# Access Compliance Report

### (Curb Ramps)

Intersection ID: 4219	Main Street: DAVIS_LAKE_PY	Cross Street: UNIVERSITY_STATION_CR	Location: SE
ADA ID: 2B8EBACCD99C	Ramp Type: Directional1	Initial Pass/Fail: Fail	Overall Compliance: No
Severity Score: 33.75			
Codes/Mitigation Info/Possible Solution		Field Measurements/Component Compliance

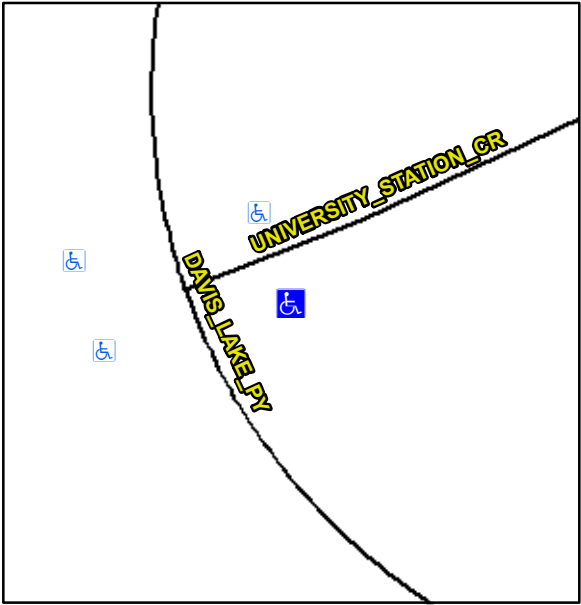
N/A		Painted X Walk1?		No		Road Slope (%)	1.3
					X Walk 1 Direction	To NW			Road X Slope (%)	8.4
					X Walk 1 Width (in)		N/A		Clear Space?	N/A
					X Walk 1 Slope (%)		1.3	N/A	Clear Space to XWalk (in)	N/A
					X Walk 1 X Slope (%)		8.4	N/A	Storm Grate/Utility Hazard?	N/A
			N/A		Ramp inside XWalk1?		N/A		Storm Grate/Utility Type	
			N/A		Any Obstructions?		N/A			N/A
					Obstruction Type			Yes	Surface Condition? (G/P)	Good
								N/A	Curb Slope (%)	N/A
Surveyor Notes:										
N/A										
PROW/ADA:										
R304.5.1, R304.2.2, R304.5.3										
Total Cost:		\$	1600.00

Possible Solutions:		Compliance		Description		Data	Compliance	Description	Data
	Remove & Replace Entire Ramp.		N/A		Ramp Length (in)		29.0	N/A	Grade Break?	N/A
			No		Ramp Width (in)		44.0	N/A	Grade Break Slope (%)	0.0
			No		Ramp Slope (%)		11.3	N/A	Grade Break XSlope (%)	0.0
			No		Ramp XSlope (%)		6.1			
			N/A		Flare Type LT		N/A	N/A	Flare Type RT	N/A
			N/A		Flare Slope LT (%)		N/A	N/A	Flare Slope RT (%)	0.0
			N/A		Flare Traversable LT?		N/A	N/A	Flare Traversable RT?	N/A
			N/A		Landing Length (in)		0.0	N/A	DWS Provided?	N/A
			N/A		Landing Width (in)		0.0	N/A	DWS Contrast?	N/A
			N/A		Landing Slope (%)		0.0	N/A	DWS Length (in)	N/A
			N/A		Landing X Slope (%)		0.0	N/A	DWS Full Width?	N/A
			N/A		Landing Curb? (Y/N)		N/A	N/A	DWS Offset LT (in)	N/A
			N/A		Shared Landing?		N/A	N/A	DWS Offset RT (in)	N/A
			N/A		Gutter Ponding?		0.0	N/A	Gutter Slope (%)	N/A
			N/A		Gutter Lip Ht (in)		0.0	N/A	Gutter X Slope (%)	N/A
